Value Engineering Study Report

Georgia Department of Transportation

STP00-0218-01(001) – P.I. No. 522790 • CSSTP-0007-00(259) - P.I. No. 0007259

Jimmy DeLoach Parkway Extension – from I-16 to US 80 and US 80/

ALTERNATIVE NO.:
I-3

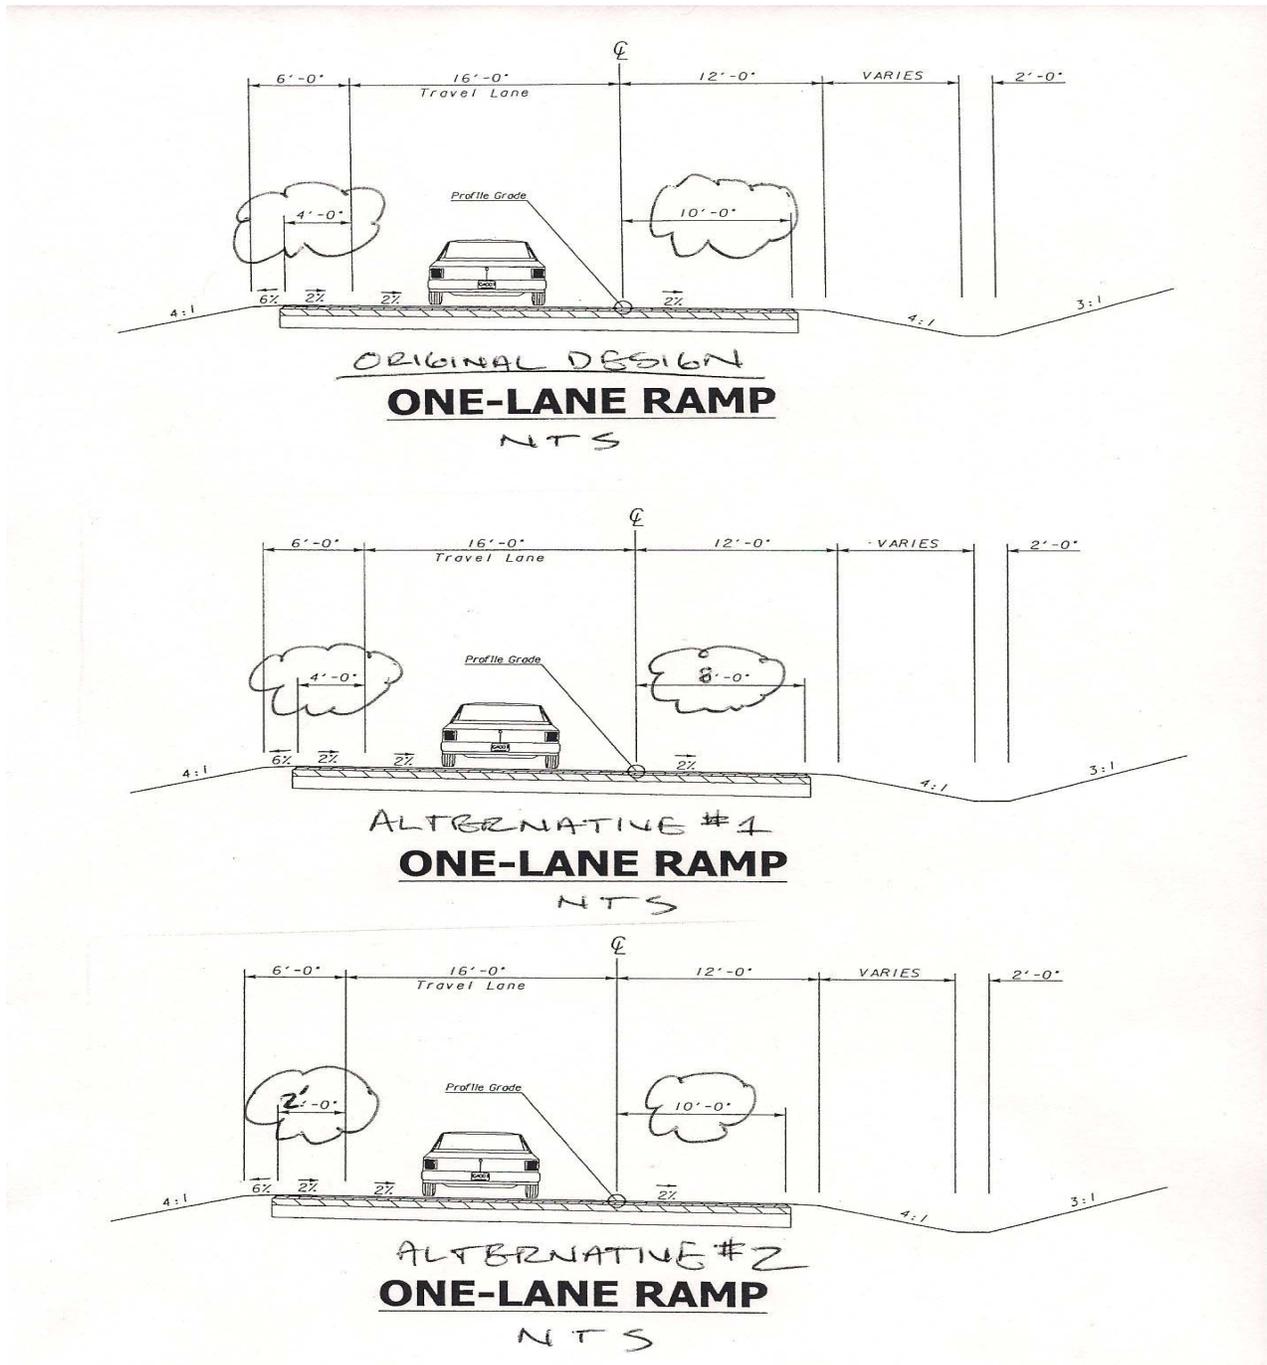
DESCRIPTION: **Reduce the sum of the ramp's paved shoulders from 14' to 12'** SHEET NO.: **1 of 4**

ALTERNATIVE NO.:
I-4

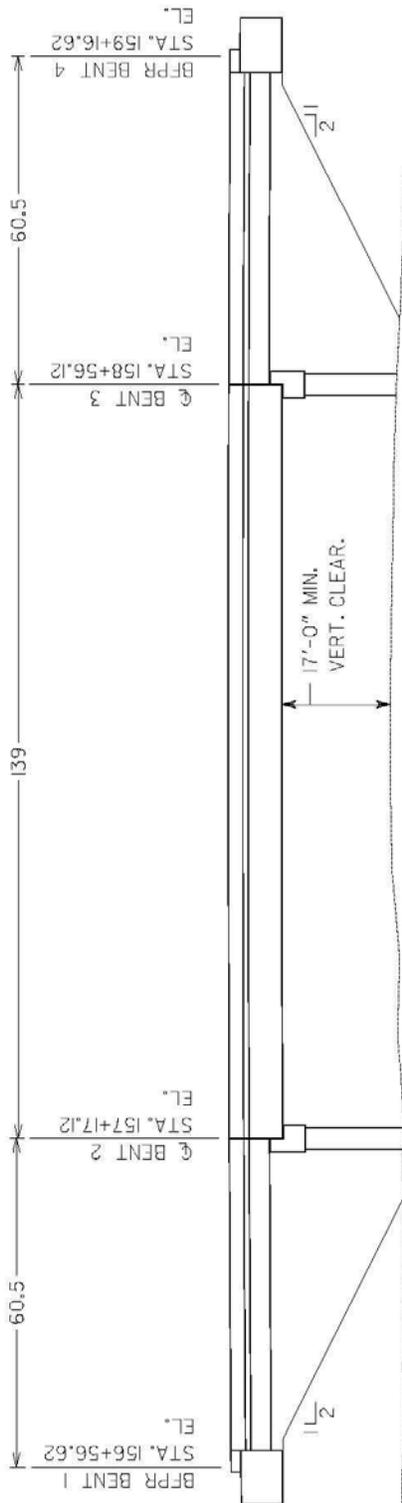
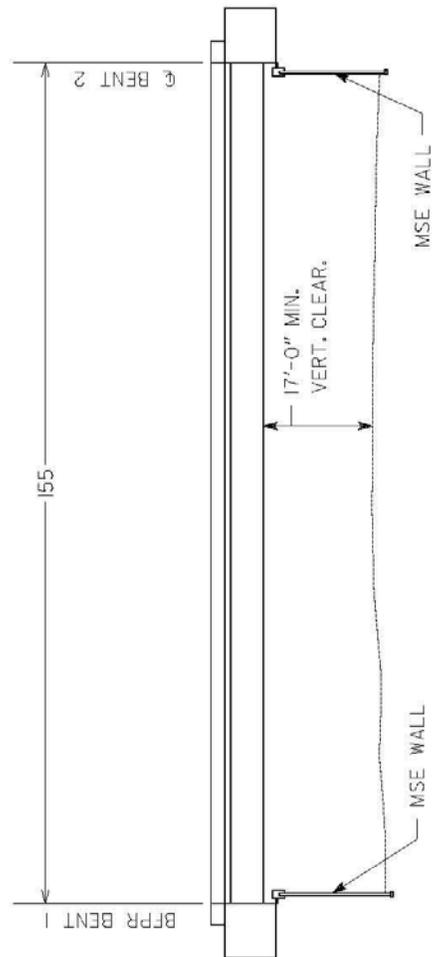
I-4	Use single span bridges w/ MSE walls	\$ 241,945	
I-6	Use 40' end spans on bridges across US 80	\$ 209,853
